City of
Richmond

Report to Development Permit Panel

File: DP 14-657872

Re: **Application by Yamamoto Architecture Inc. for a Development Permit at 9051 and 9055 Dayton Avenue**

DRAWING TITLE		SITE SECTIONS	
PROJECT		TOWNHOUSE DEVELOPMENT	
Yamamoto Architecture Inc.		9851 8855 DAYTON AVE RICHMOND, B.C.	
SCALE	1/16"=1'-0"	SHEET	
DATE	SEPT. 16, 2012	DRAWN	TY
CHECKED		PROJ.

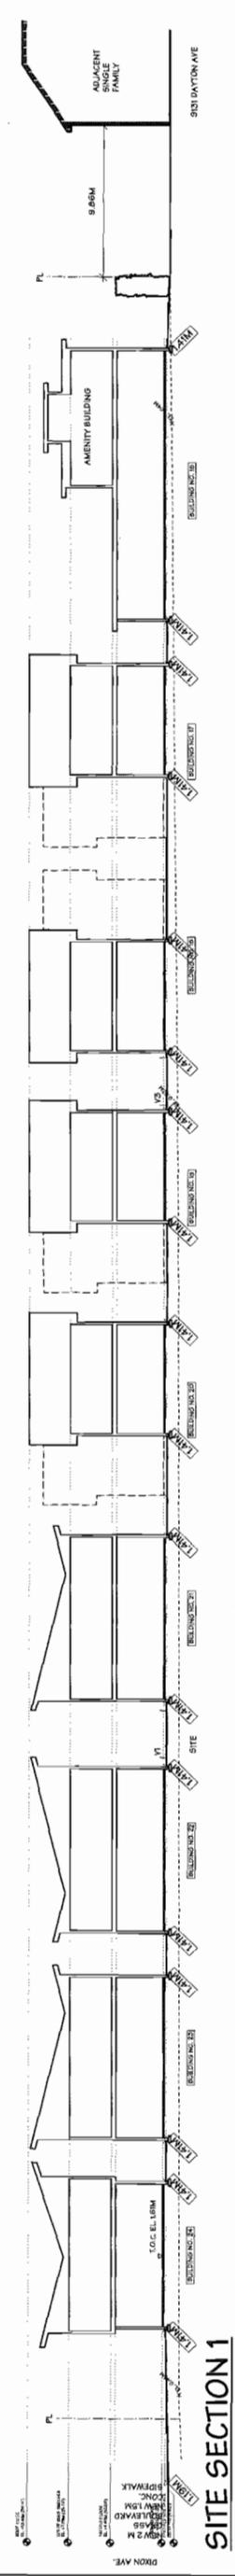
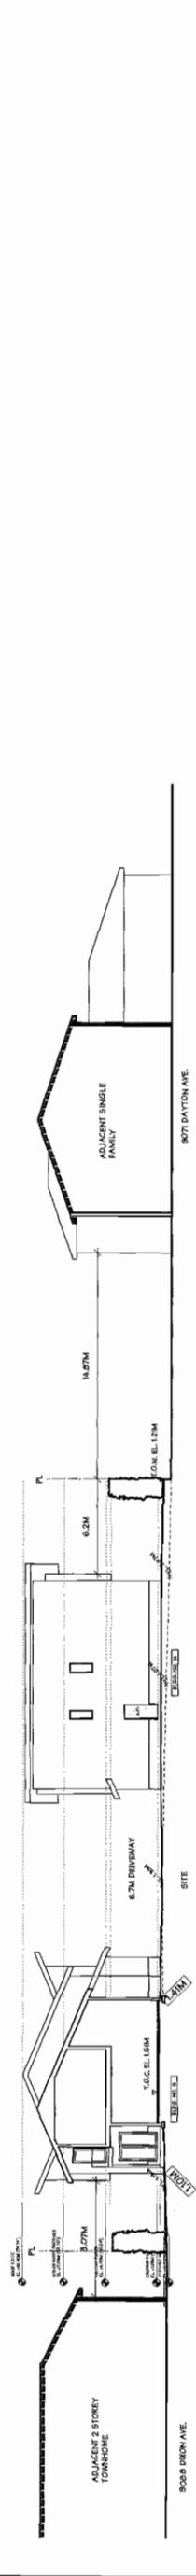
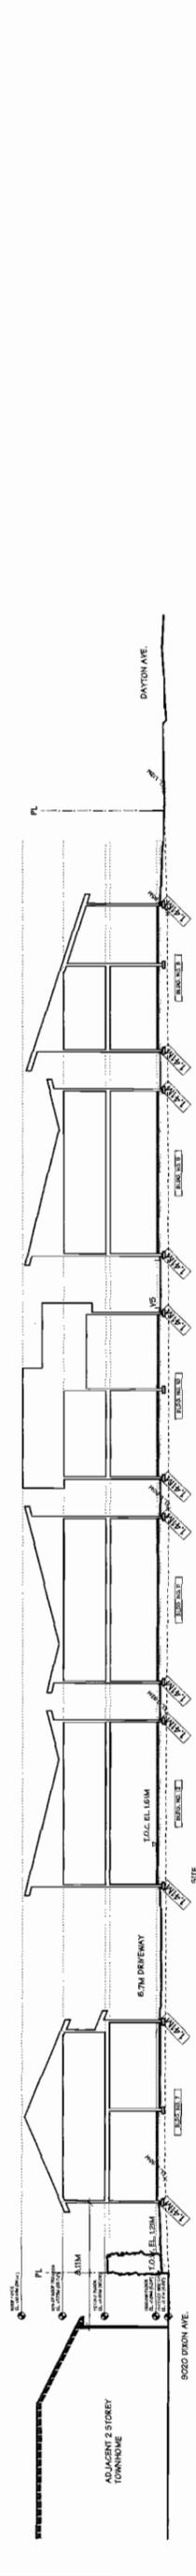
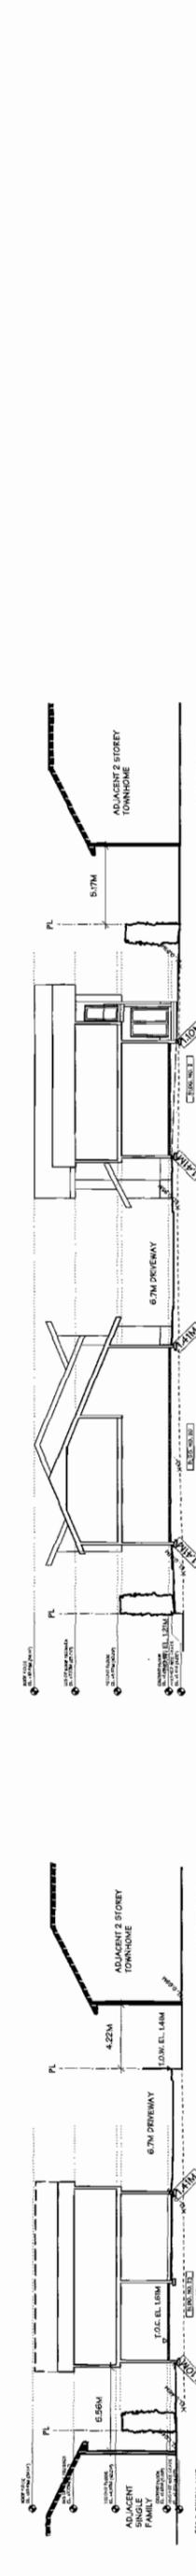
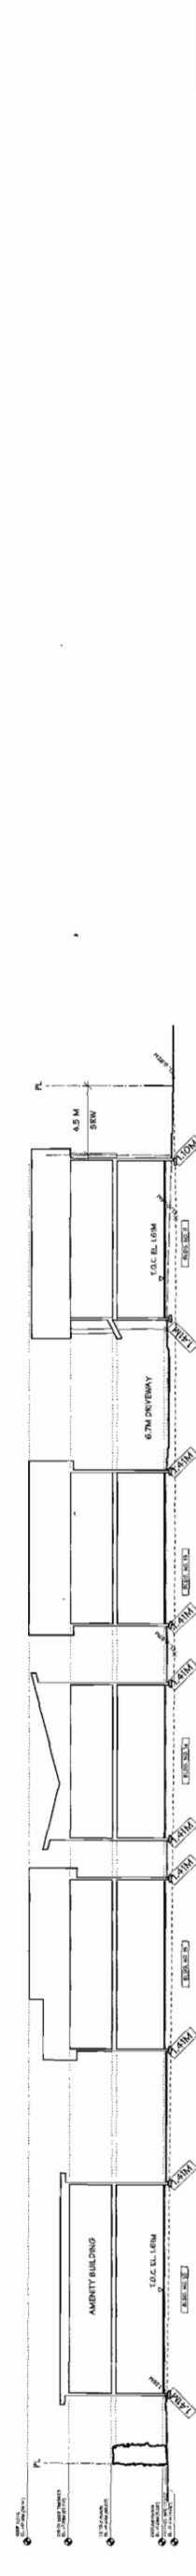
I have attached the letter that was sent to all the Dayton Avenue neighbours, and the neighbours have asked me to represent them in inquiring on our choices in this matter. By looking at the Section Sheet SK1, the proposed new retaining wall is comprised of railway ties, and the neighbours are concerned about possible water runoff into their property since the townhouse complex is elevated higher. A solid concrete foundation could be a better solution, but that is a choice of the geotechnical engineer and financial economics. The neighbours are also concerned of the initial spacing of the proposed new tree hedging. The neighbours would prefer if they had no choice of keeping the original trees, that the new hedges be a completed privacy barrier, not one that will take the next ten years to mature into a privacy barrier.

UNIT-Ba

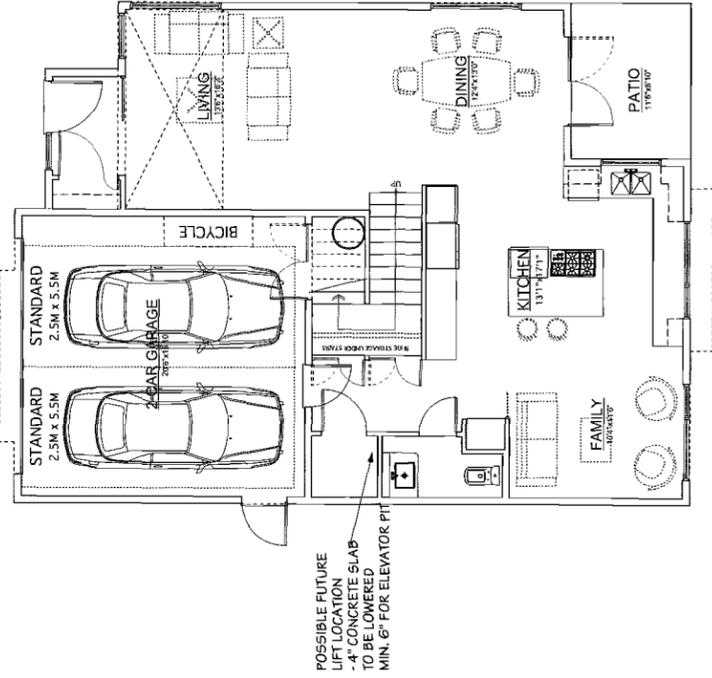
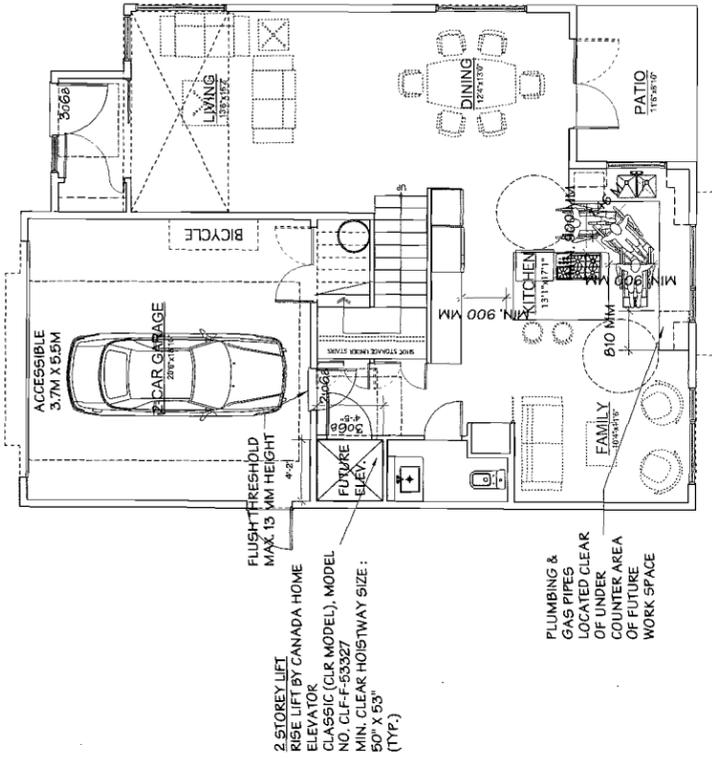
- interesting project; character is unique; appreciate that the applicant trying to do something different in Richmond – *Noted.*
- concern on the roofline of the middle unit at the western side of the development (A2 Unit) with a simple wing style; creates blank, tall and boxy façades that are visible to the adjacent development; consider further design development to this type of unit; other units are successful and bring a nice contemporary look to the development – *Facade improved with band of hardi board with metal reveals to highlight roof, box out to provide depth and additional windows to provide animation.*
